Notice of Product ECN – TCG121XGLPAPNN-AN20

12.1inch XGA TFT Change

TCG121XGLPAPNN-AN20(-T)

TYPE : TCG121XGLPAPNN-AN20-TA

Material	Treatment	Approved	Checked	Checked	Drawn	Scale	Title	KYOCERA		Year-Month-Day	Size
材質	処理	'13.12.06		'13.12.06	倉元	1:1 (NTS)	TCG121XGLPAPNN	Drawing No.		'13.11.29	2
Quantity	Description; RoHS	朝倉	車	倉元	Outline Dimensions		121A8072400-2		1/2		
製作数	備考 12079-10276-4

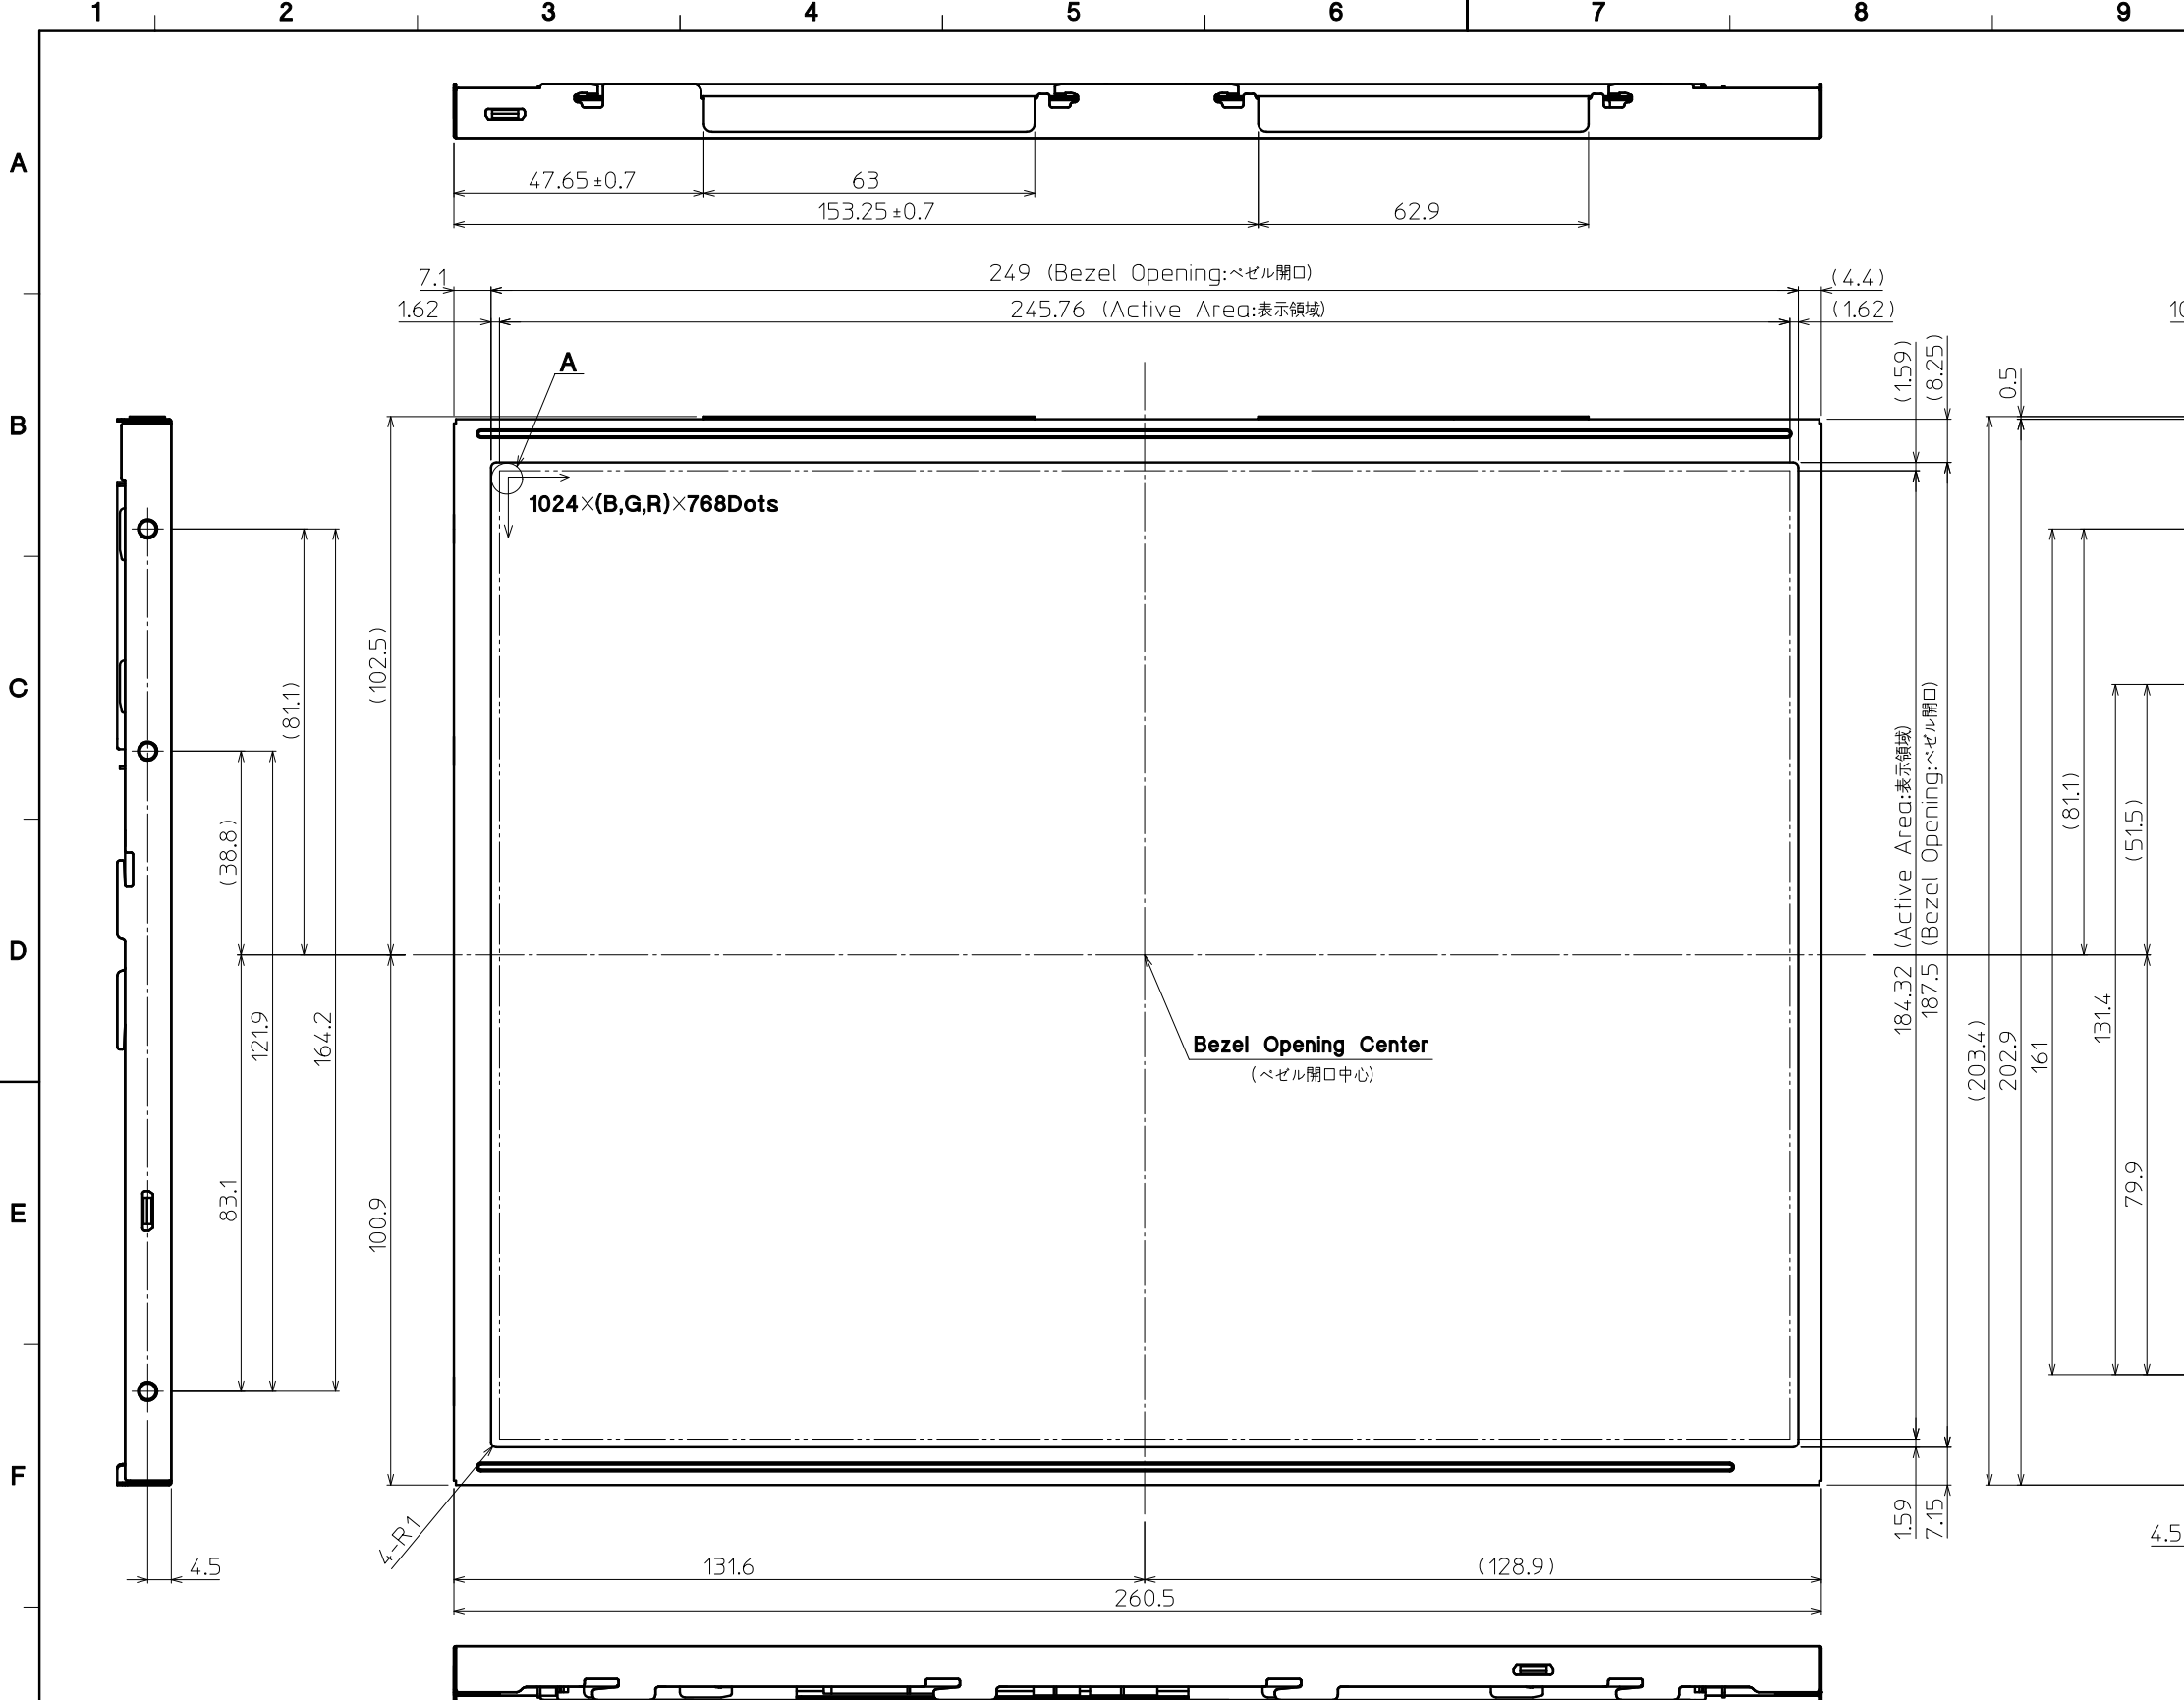
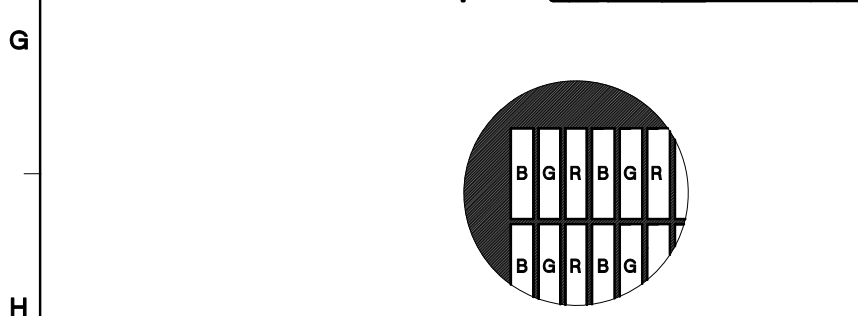
No	Description	Drawn	Checked	Checked	Approved
△	Change Matching Connector. (適合コネクタを変更)	'19.11.18 伊原	'19.11.18 倉元		'19.11.22 宇佐美
△	Add Connector. (コネクタも追加)	'25.01.10 蔭山	'25.01.16 本間		'25.01.17 加藤

- Note. (注記)
- Connector CN1: 20186-020E-11F (I-PEX) FI-SEB20P-HFE (JAE)
CN2: SM06B-SHLS-G-TF(LF)(SN) (JST)
△ 20497-020U-F (I-PEX)
△ 20497-T20U-F (I-PEX)
 - Matching Connector CN1: FI-S20S (JAE)
CN2: SHLP-06V-S-B (JST) (Gold plating)
 - The Information of LCD is displayed starting at the upper left hand corner, moving right then down to the lower right hand corner.
(LCDにおいて、画像データの表示は左上コーナーから始まり、右へ進み下へ送られ右下コーナーへ向かう。)

Material 材質	Treatment 処理	Approved '13.12.06	Checked	Checked '13.12.06	Drawn 倉元	Scale 1:1	Title TCG121XGLPAPNN		Year-Month-Day '13.11.29	Size 2
Quantity 製作数	Description; 備考	RoHS 12079-10276-4	朝倉	車			Outline Dimensions		Drawing No. 121A8072400-2	2/2

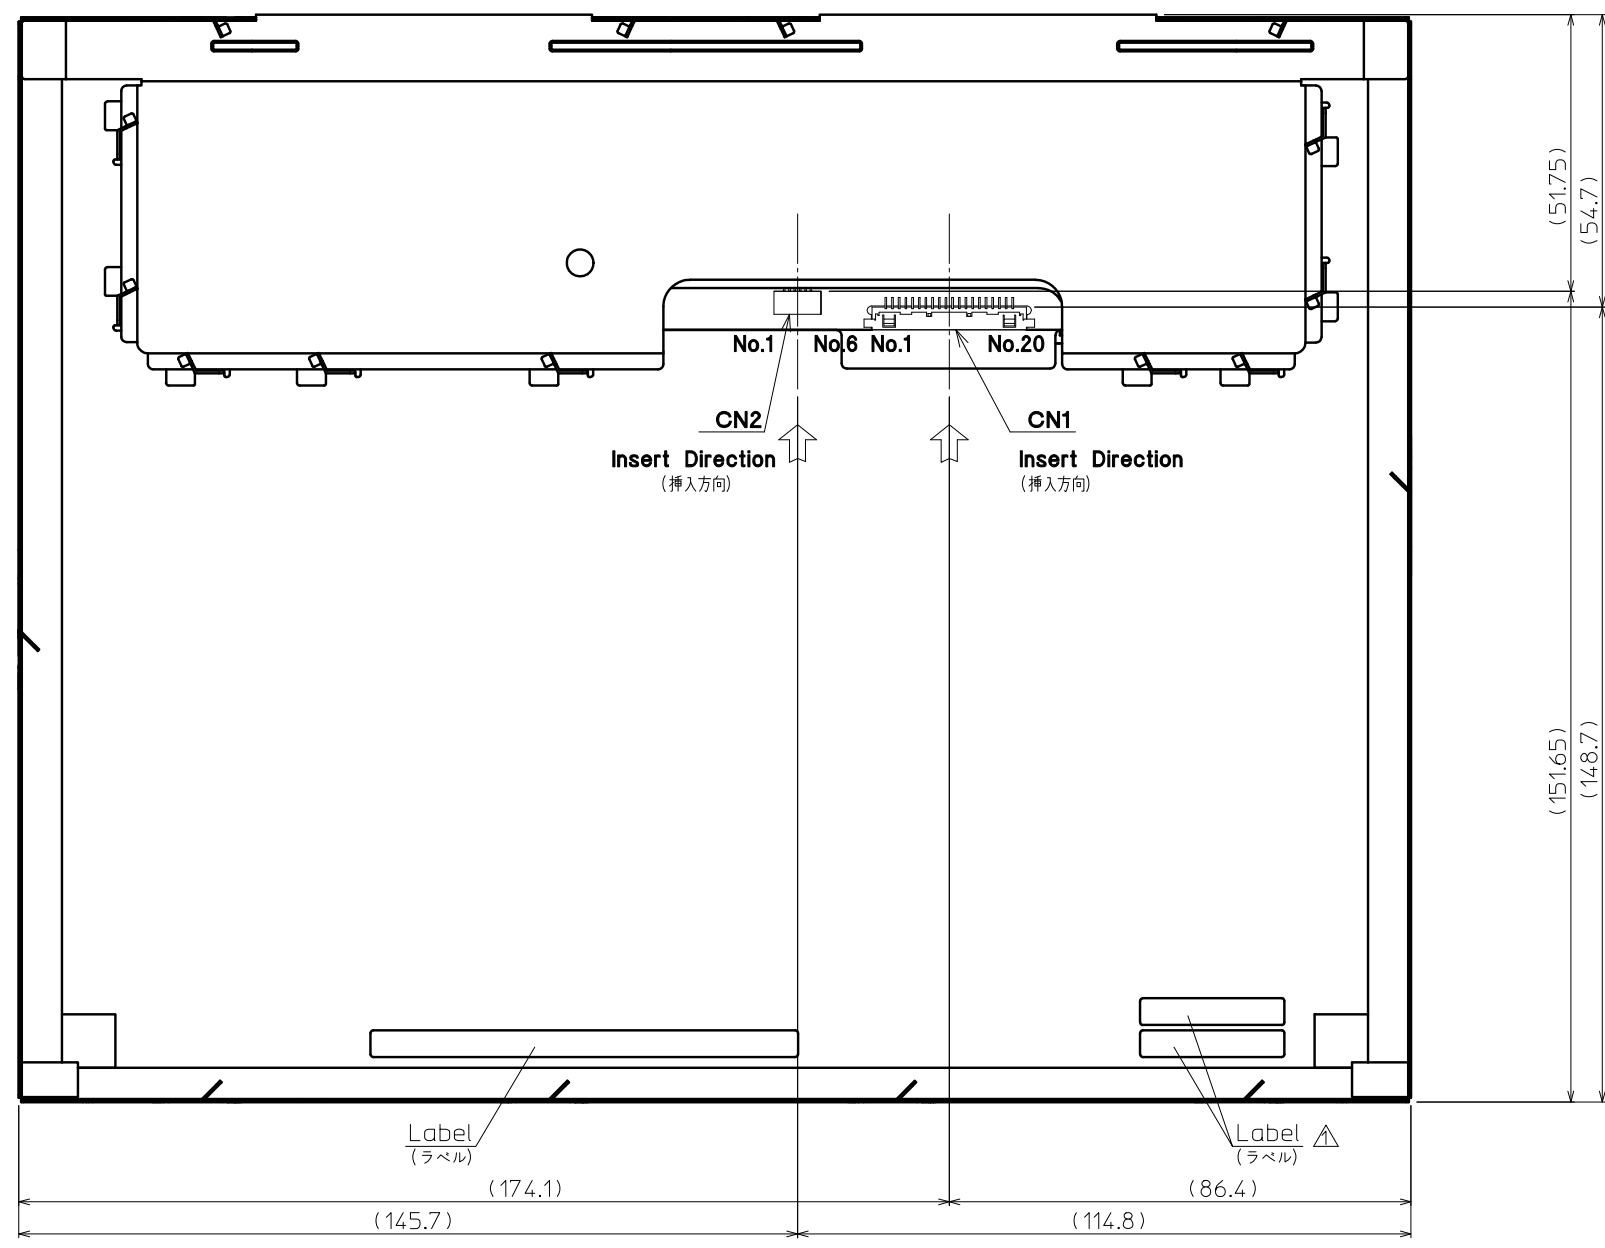
No	Description	Drawn	Checked	Checked	Approved
△	·Delete a part of the label. (ラベルの一部を削除)	'19.11.18 伊原	'19.11.18 倉元		'19.11.22 宇佐美
△	·1/2 Revision up.	'25.01.10 蔭山	'25.01.16 本間		'25.01.17 加藤
